Final Environmental Impact Statement for  
**Developing Home Port Facilities for  
Three NIMITZ-Class Aircraft Carriers  
in Support of the U.S. Pacific Fleet**

Volume 7 – Part A  
Comments and Responses for Coronado, California  
July 1999

**Comments and Responses for  
Coronado, California  
Federal, State, and Local Agencies  
and Organizations**

Figure 3.18-1. Cumulative Projects in San Diego Area

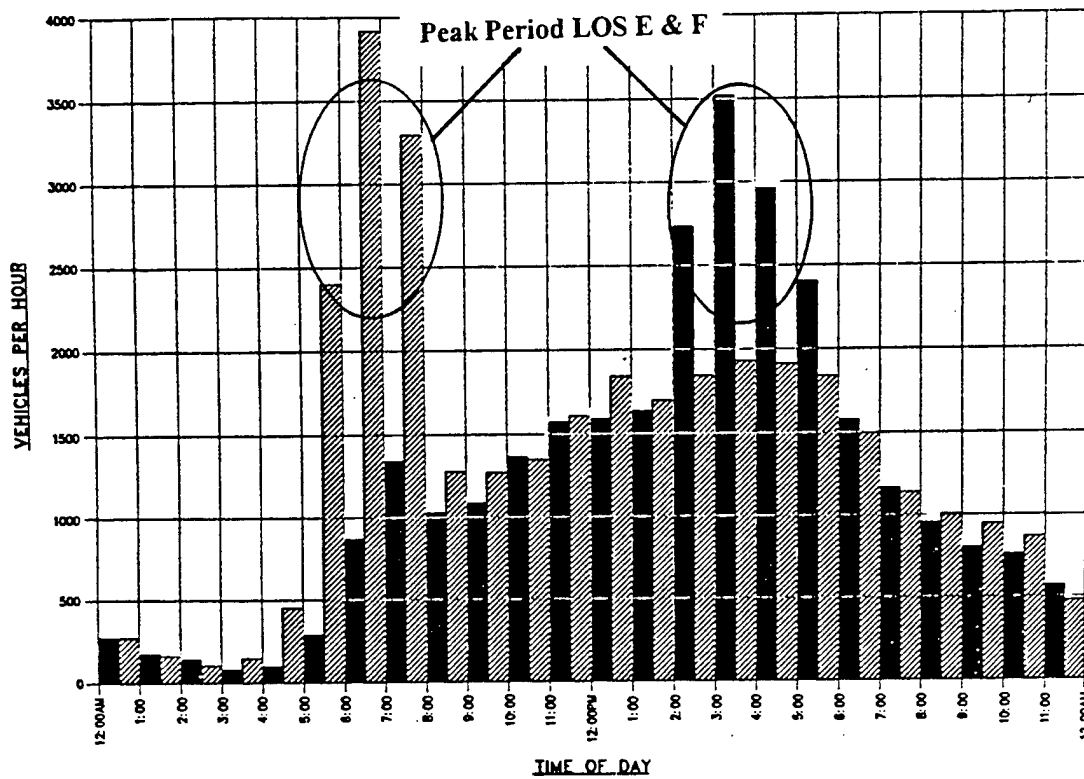
The DEIS Section 3.18 *NASM Cumulative Impacts* Figure 3.18-1 Cumulative Projects in San Diego does not identify any past, present or foreseeable future project in or related to the transportation corridor serving the project area. In fact, there appears to be a deliberate attempt to avoid identifying such projects. Great care has been taken to identify projects as far away as Old Town and North Bay, yet large projects in and around the transportation corridor serving the project area have been excluded from cumulative analysis. Failure to consider the cumulative impacts of projects on the transportation corridor serving the project area constitutes a serious flaw in this document.
